ADDENDUM NO. 2

PROJECT NAME: Othmer Hall Machine Shop Renovation
UNL PROJECT NUMBER: 10151
BID INVITATION NUMBER: 2410-14-7200

Project Name: Othmer Hall Machine Shop Renovation

M5.0

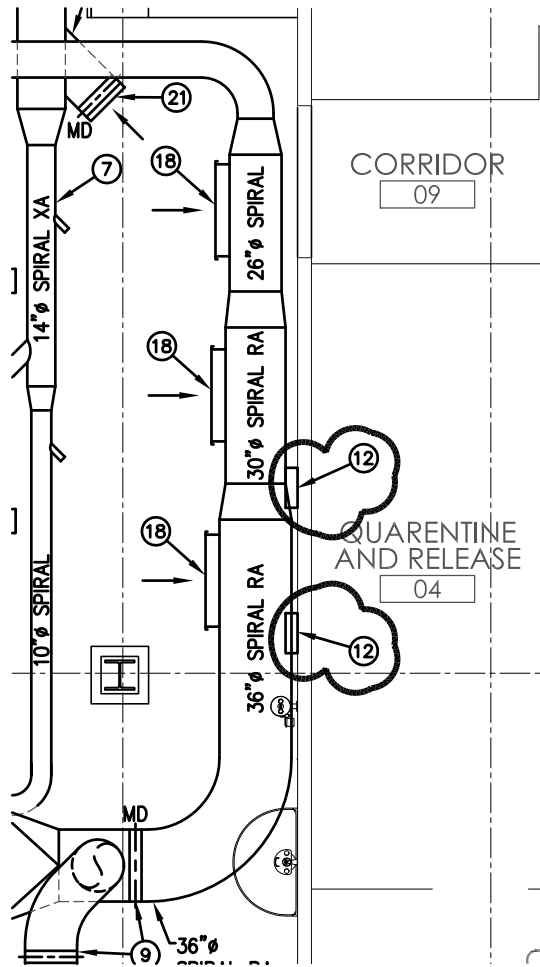
A. See Attachment M5.0-1 for revisions to Variable Air Volume Box Schedule and Exhaust Fan Schedule.
